**PLANNING APPLICATION FOR A LANDFILL SITE AT LAYBROOK BRICKWORKS QUARRY
REVIEW OF THE PLANNING AND ENVIRONMENTAL SUBMISSIONS**

Appendix 2: Hydrological report

Knepp Castle Estate: Hydrological Impact Report of Laybrook Landfill Site

22nd September 2009

Figure 8. Generalised stratigraphy of the Weald Clay (Radley, 1999).

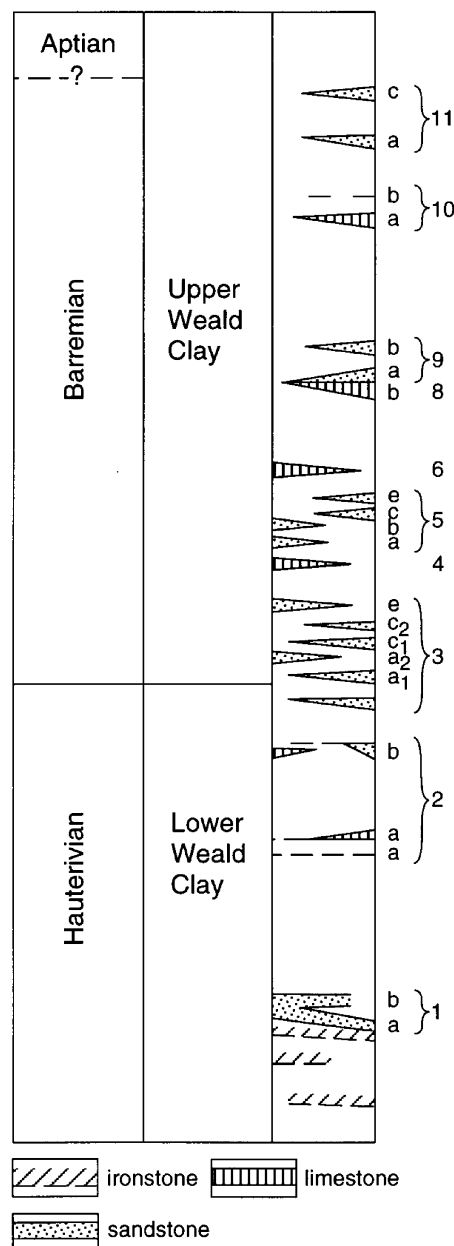
This lateral movement of groundwater which is a highlighted concern during the construction of the engineered liner may continue to pose a risk to the integrity of the liner after its installation. There is the potential for impeded groundwater to build up in these sandstone, siltstone and limestone laminations behind the low permeability engineered liner. Under lower groundwater pressure conditions, this would result in an increase in the hydraulic gradient across the liner and increased groundwater seepage. In a higher groundwater pressure environment, there is the potential for the structural integrity of the engineered liner being undermined. The occurrence of these higher permeability laminations is well documented in other studies (see figure 8). In the

eventuality that groundwater seepage increased or the liner breached, two significant environmental risks would be posed:

- Increased seepage as a result of the higher hydraulic gradient and/or localised failure of the engineered liner would allow greater groundwater ingress to the landfill. This could result in an increase in leachate formation and the potential for heavy metal mobilisation.
- Localised failure of the low permeability liner in the base of the landfill would undermine the leachate collection system and may provide a contamination vector for leachate and other pollutants to the surrounding environment.

- A full investigation of the groundwater dynamics associated with sandstone, siltstone and limestone laminations within the Weald Clay has not been presented. Given the experiences of other civil engineering

work within the Weald Clays and the associated geotechnical and groundwater information, the risk of increased seepage and potential breaching of the engineered liner needs to be addressed and planned for within the landfill design.
